4 SUBMISSION RESPONSES – VOLUME B

4.1 B1 - Dredge Pump-out Operations – Fisheries Issues

Figure E-1: Average densities (per m²) of spionid and capitellid worms (error bars represent ±S.E., n = 5/site/time), along with the percentage of fine sediment (<0.075 mm) and concentrations of total phosphorus and nitrogen in bed sediments (mg/kg)

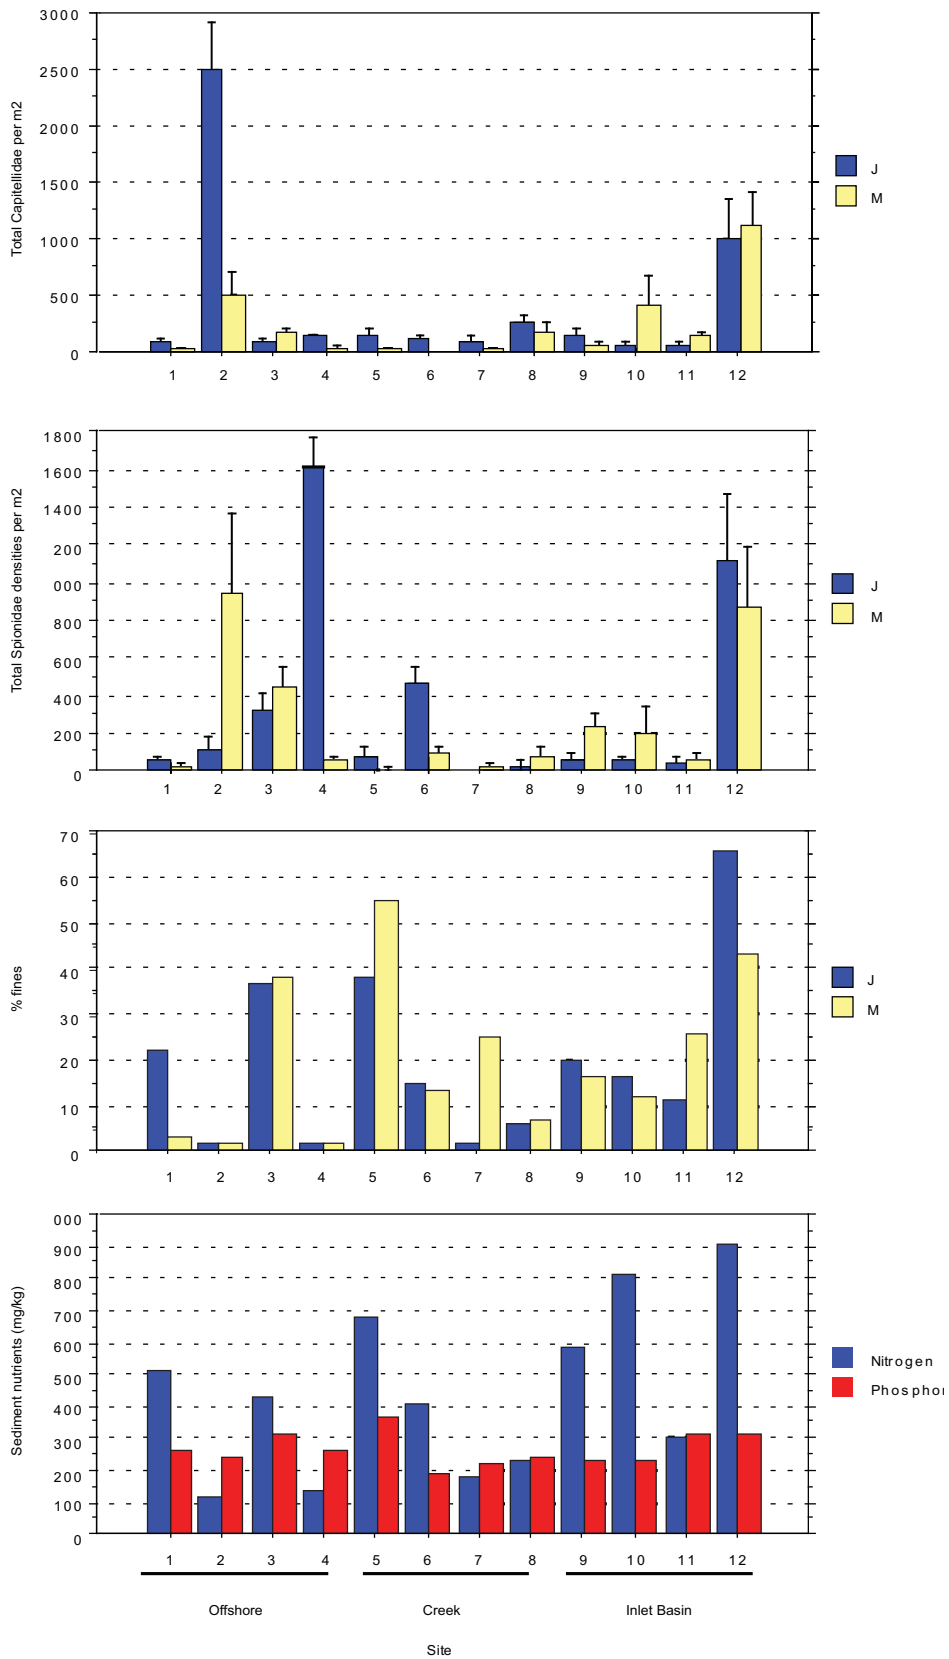
ANZECC/ARMCANZ (2000) suggests that average capitellid densities >1000 individuals per m² may be indicative of nutrient enrichment. As shown in **Figure E-1**, site 2 in January 2006 (offshore tidal flats), and site 12 in both months (Creek habitat), had average capitellid densities ≥ 1000 individuals/m². Average densities of spionid worms were >800 individuals/m² at site 4 (January), site 12 (January and March) and site 2 (March). These results may suggest that Serpentine Inlet represent a nutrient enriched environment, although in the absence of a true baseline, it is not possible to determine whether this represents a natural or anthropogenic impact.
